WORKSHOP AGENDA

Planning Commission

July 11, 2023 @ 5:30 PM

Item Title: Site Plan - Marlowe La Vergne - 376 Apartments on 27.49 Acres. Requested by Kimley Horn. Property located at 243 Blair Road (Tax Map 32, Parcel 6). R-3 (High Density Residential) Zoning District. Property owned by Martin Shofner.

C1.0

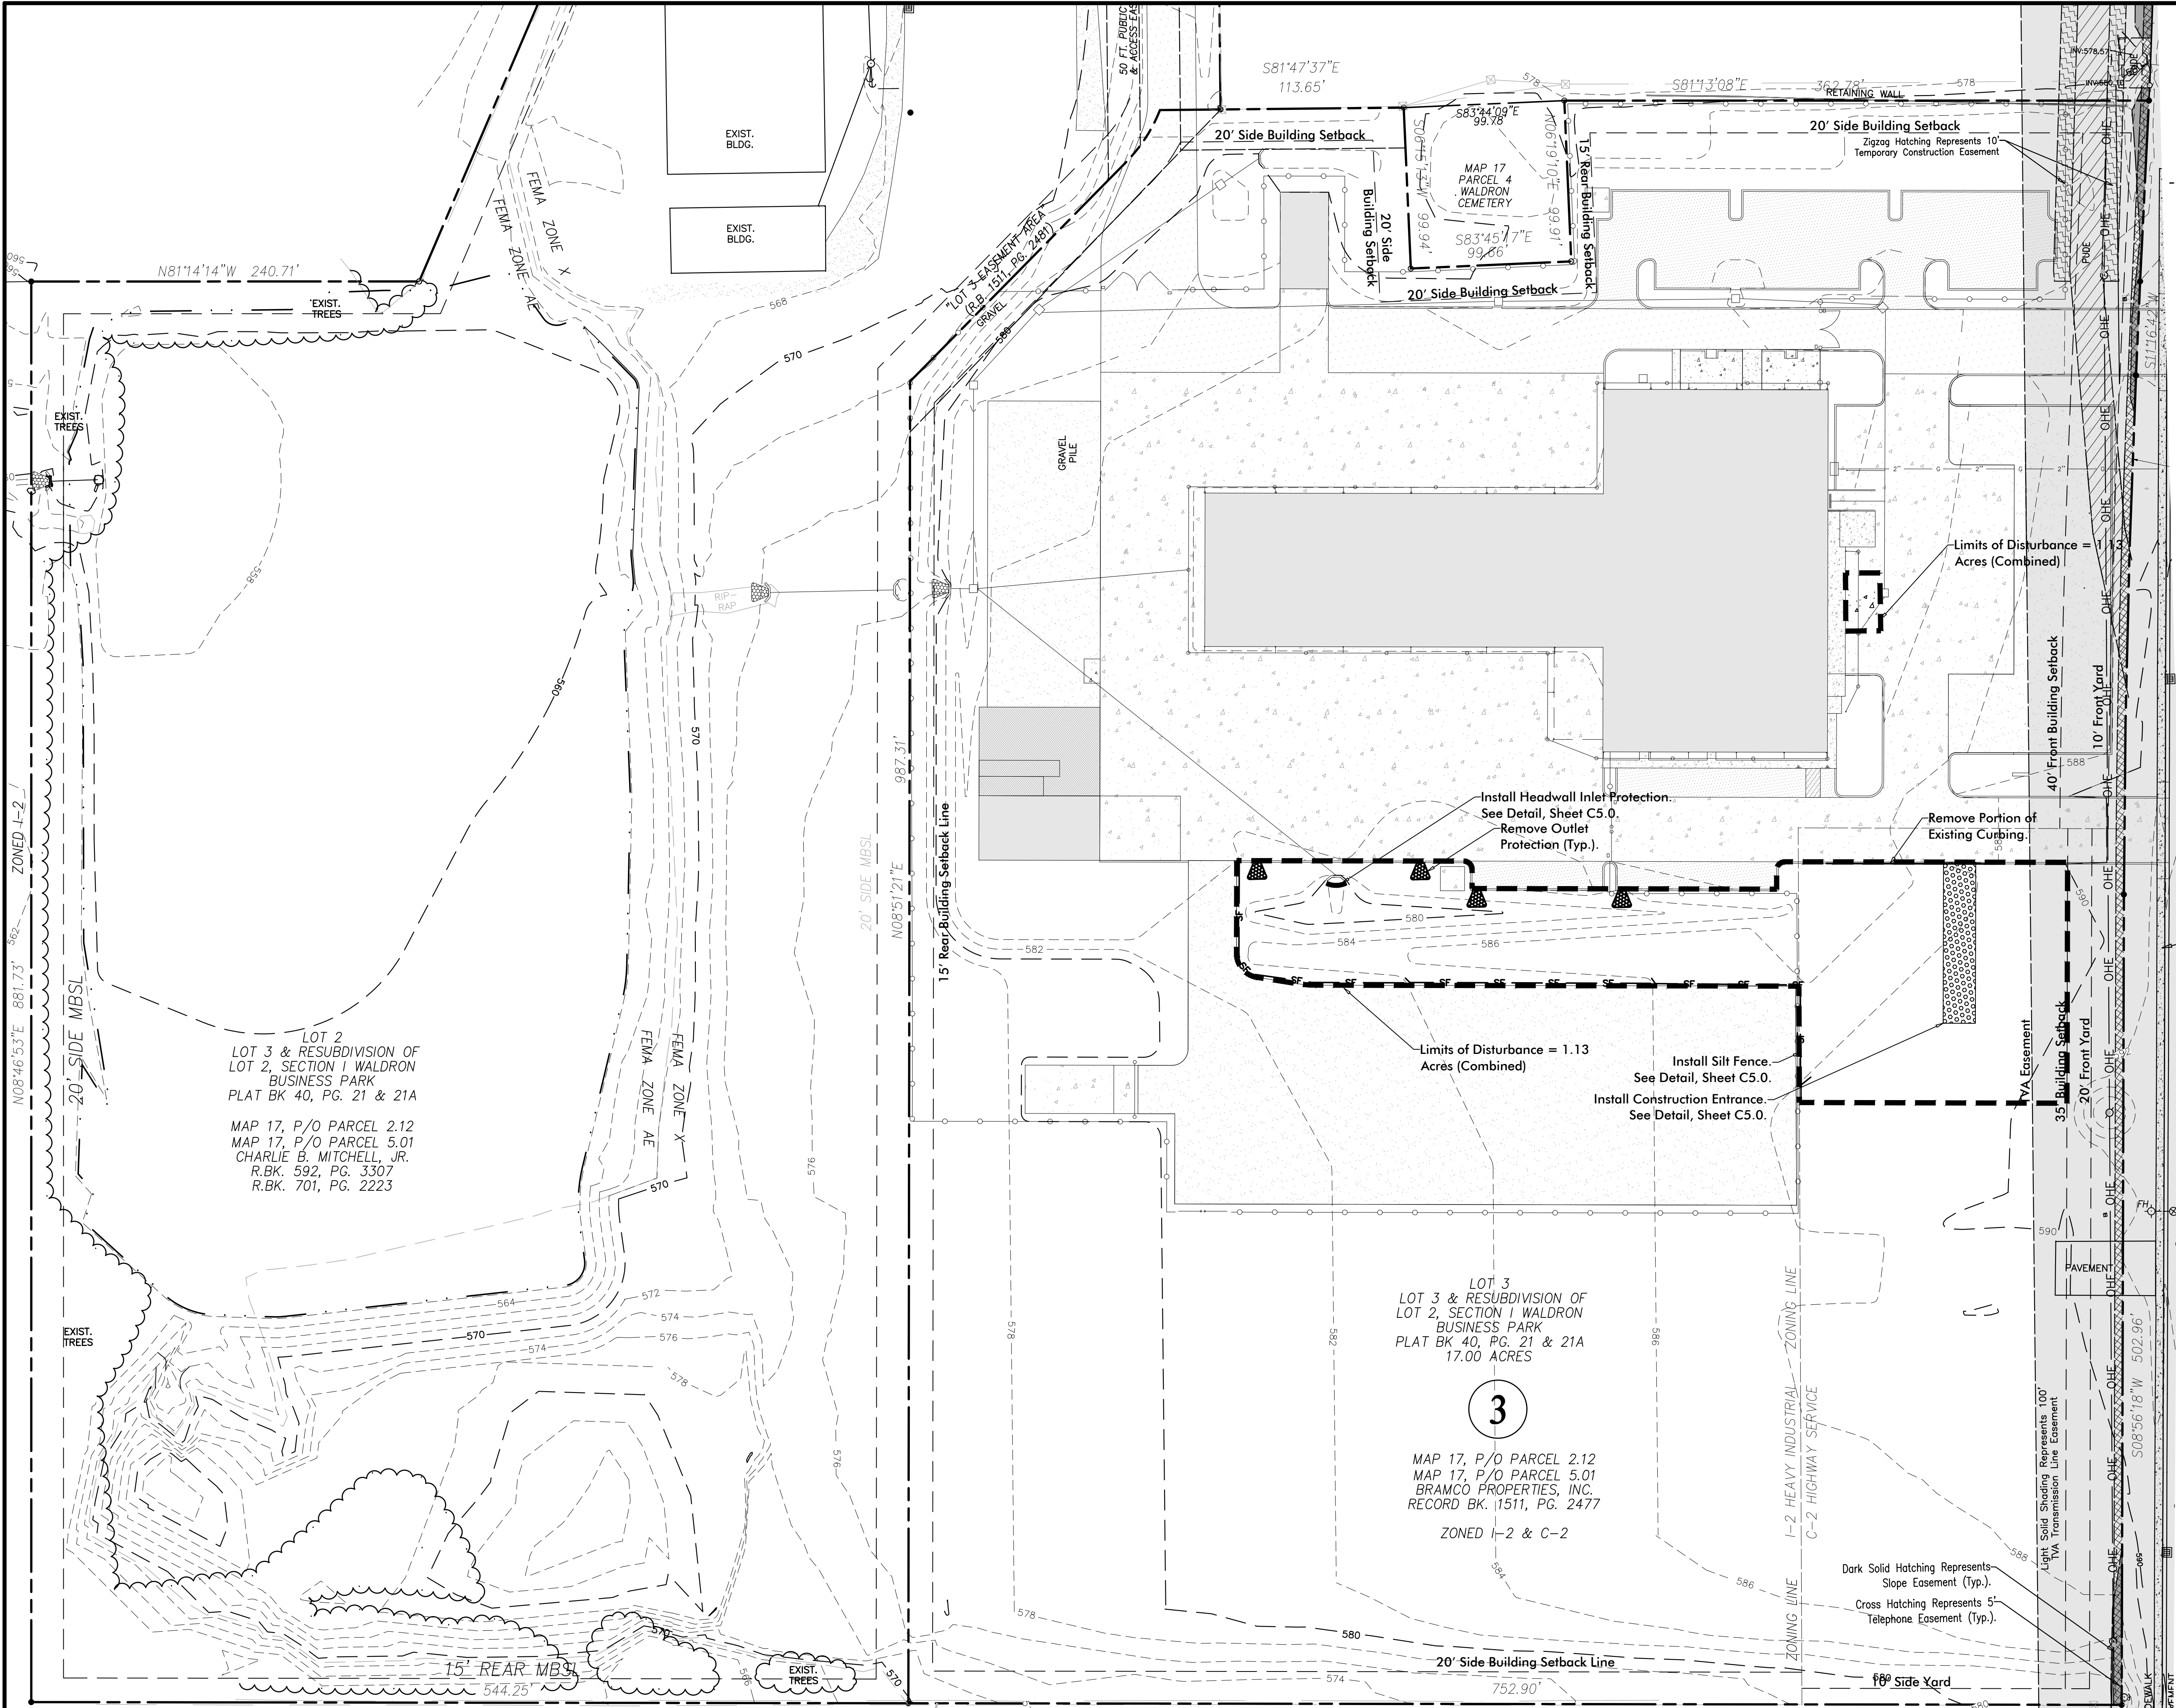
- 1 (Sheet C1.0) Provide dimension from ROW of Waldron Road to edge of new parking area. Provide width of island between new parking area and existing drive. Provide dimensions sufficient to field locate Rental Ready Expansion area.
- 2 (Sheet C1.0) Confirm that additional handicap spaces are not required with this parking expansion.
- 3 (Sheet C1.0) Provide dimensions of parking spaces and travel lanes in parking area.
- 4 (For information) Loading dock addition will require

C5.0

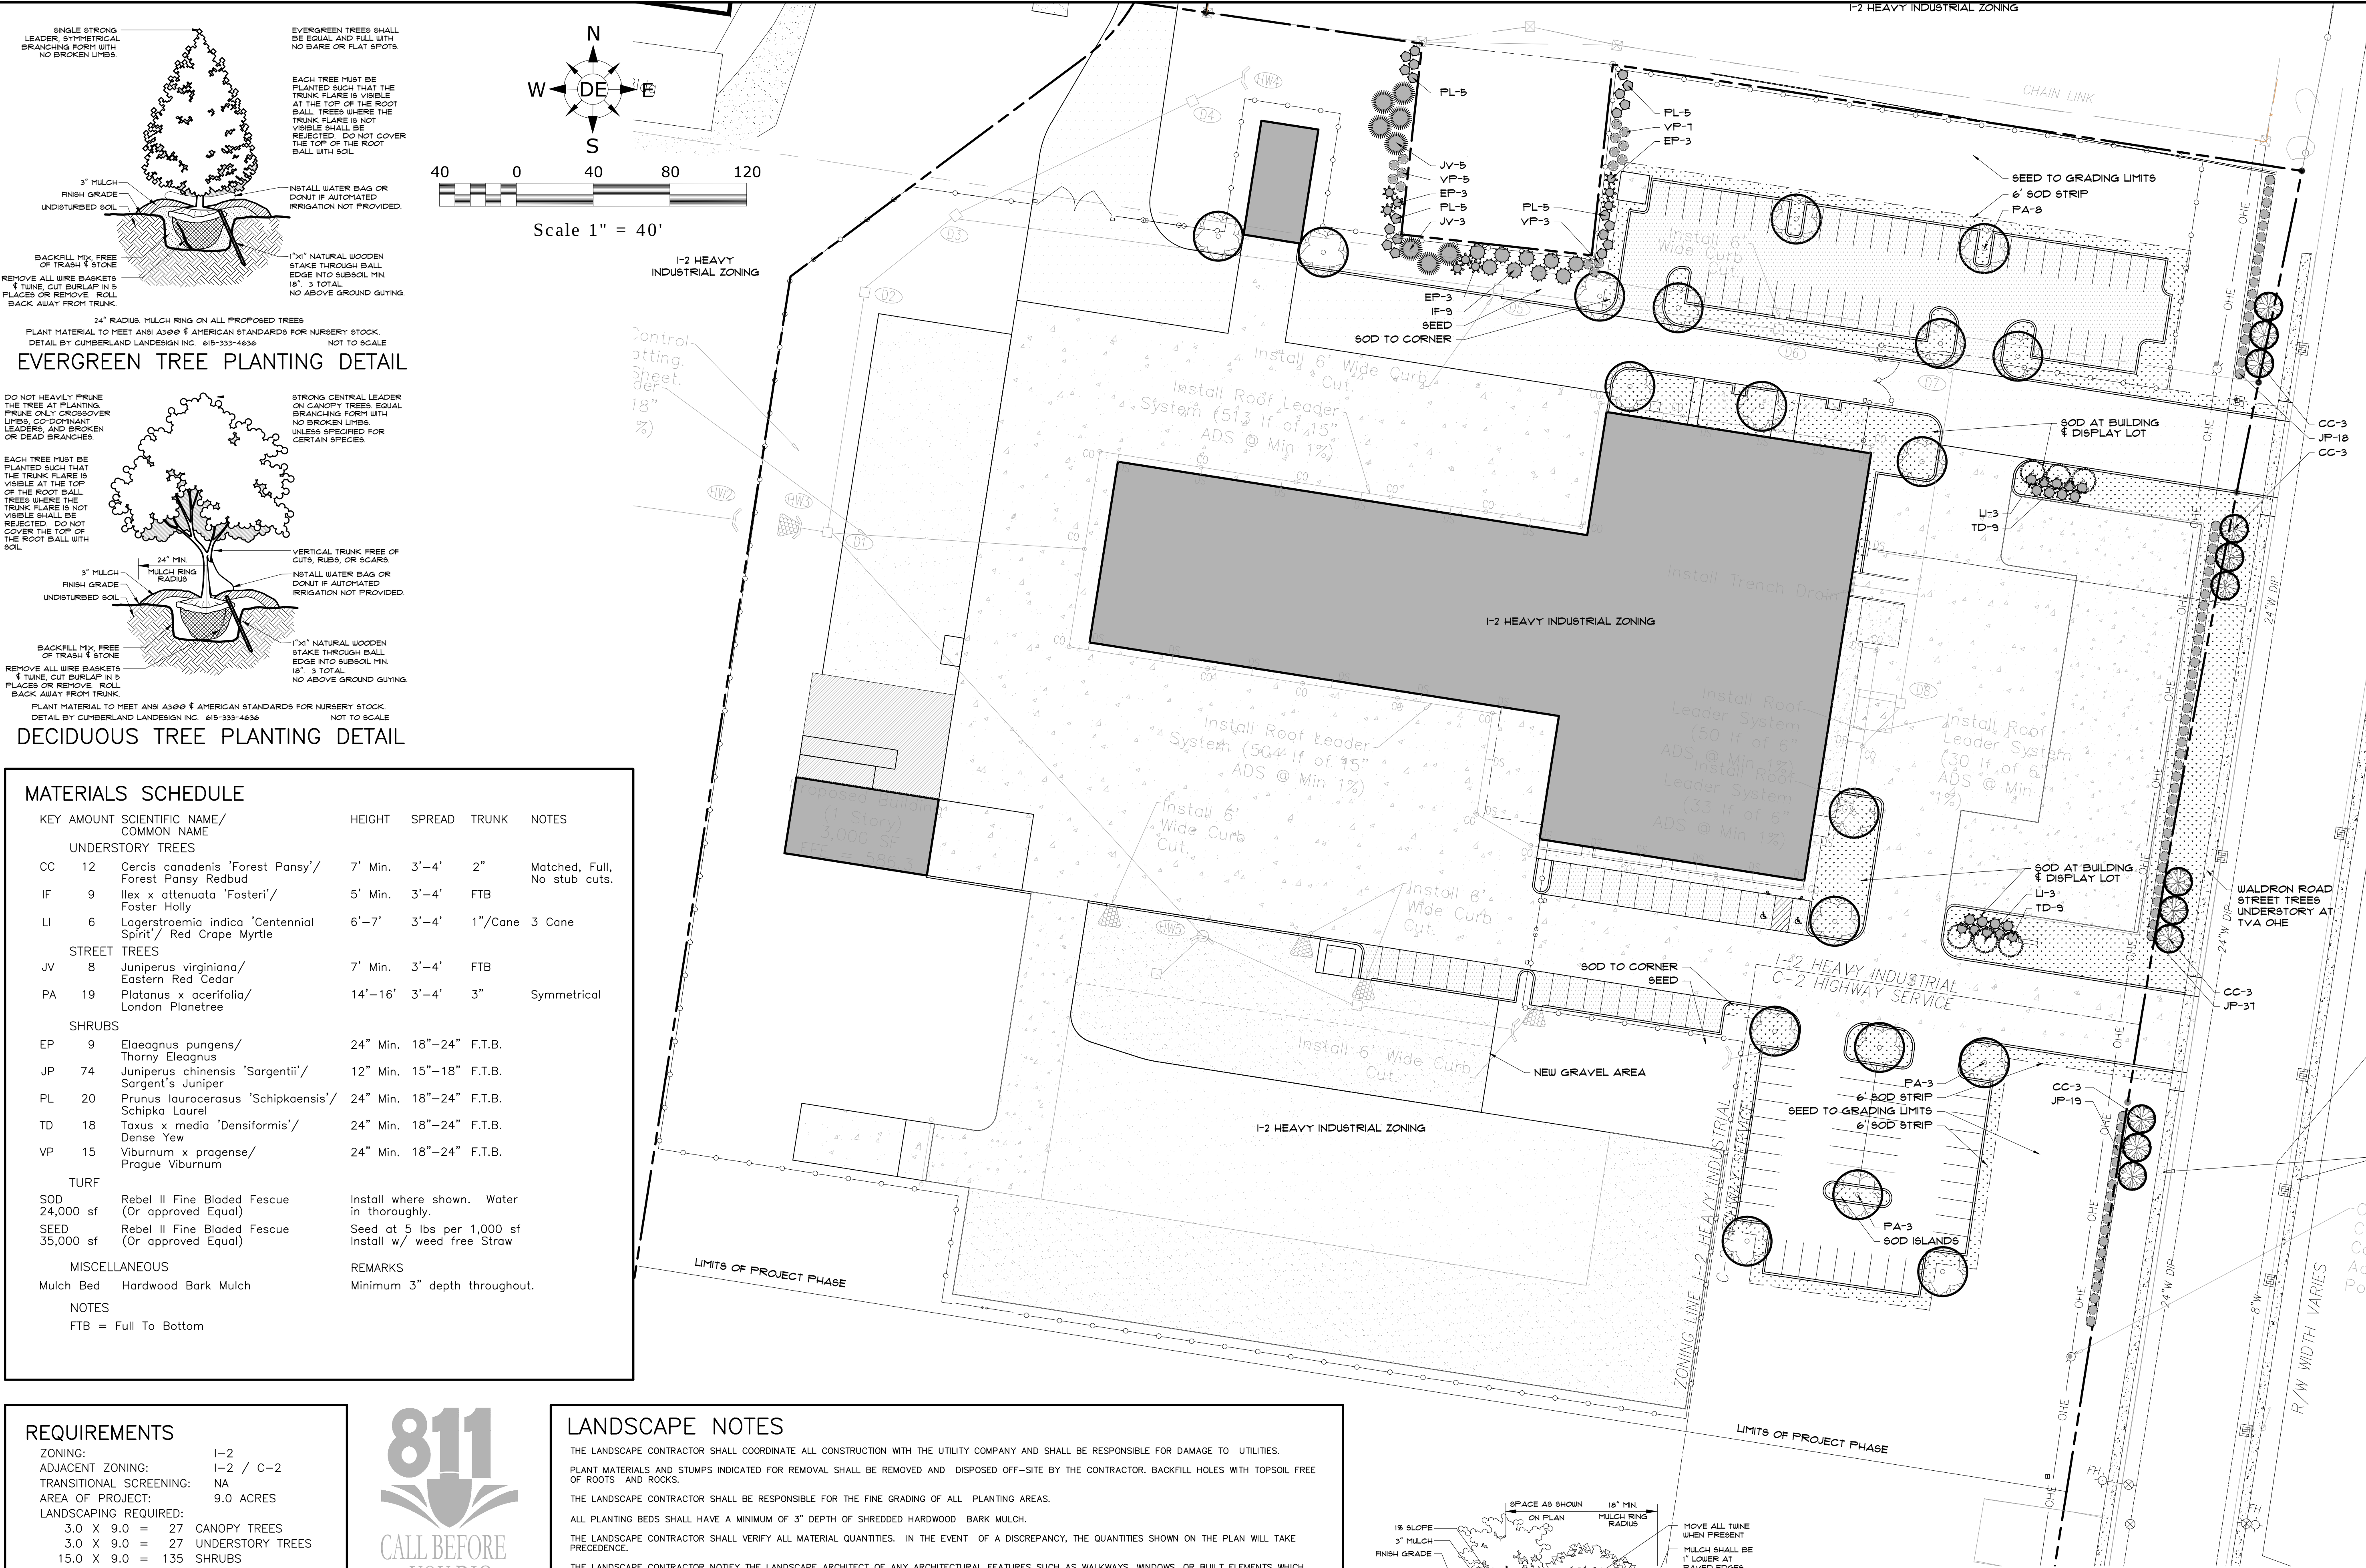
5 (Sheet C5.0) The Planning Commission interprets a dustless surface as, at a minimum, a DBST section meeting the requirements of TDOT Specifications 405.06B. The "Dustless Surface Area" section shown is an SBST and does not meet this criteria.
